United States Department of the Interior

SM-810001  
3800  
(U-201)

*These stipulations  
made part of mine  
plan July 22, 1981*

ADDITIONAL STIPULATIONS

IDEALIZED STREAM MEANDER PAT. .N

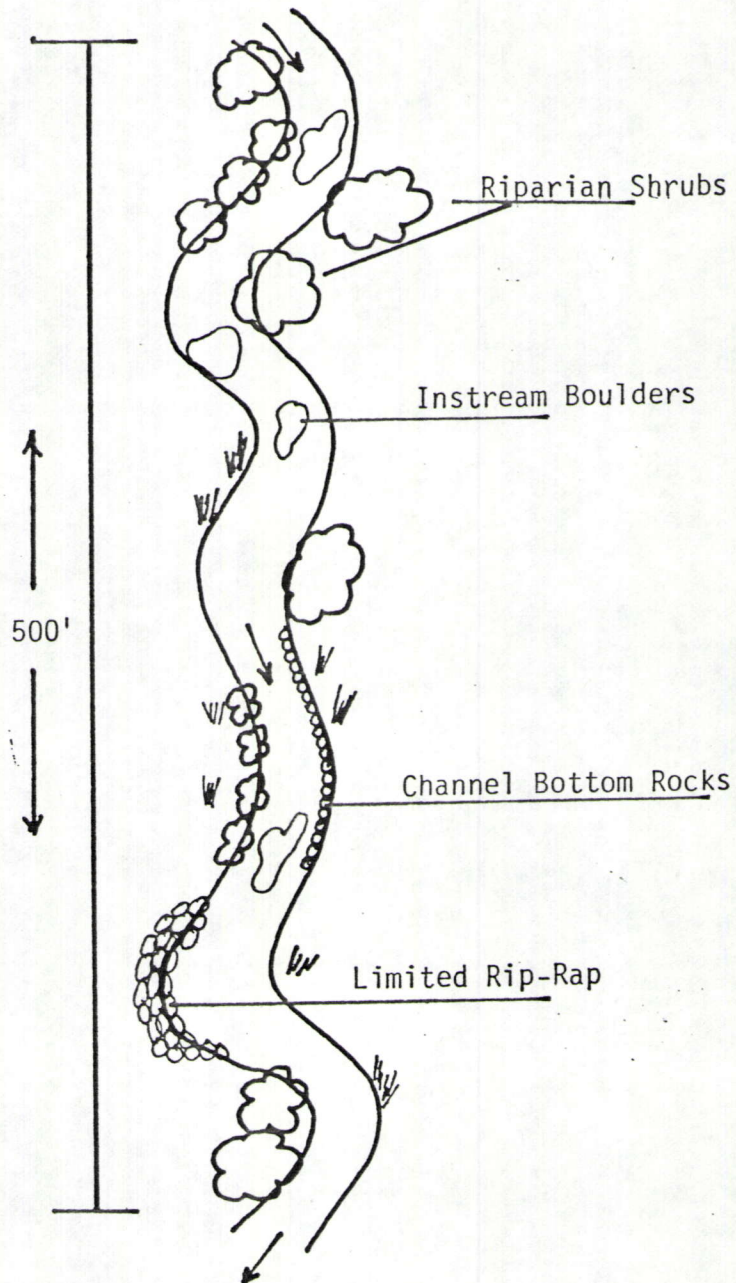
- F. Stream banks shall be revegetated with native riparian vegetation. Examples of such species include: willow, red alder, aspen, wild rose, squawbush, poplar, and sedges (Juncus sp.). Bank stabilization will be most successful with tree and shrub species. Native riparian grasses will recolonize the area after cessation of disturbance. Species selection will be prior to the conclusion of the first mining season as specified in VII. (below).

- G. Instream boulders with a diameter of 1.0'-1.5' feet shall be placed at irregular intervals to produce pool and backwater areas. Within the 2200' channel 25-30 boulders should be placed (Attachment 1).
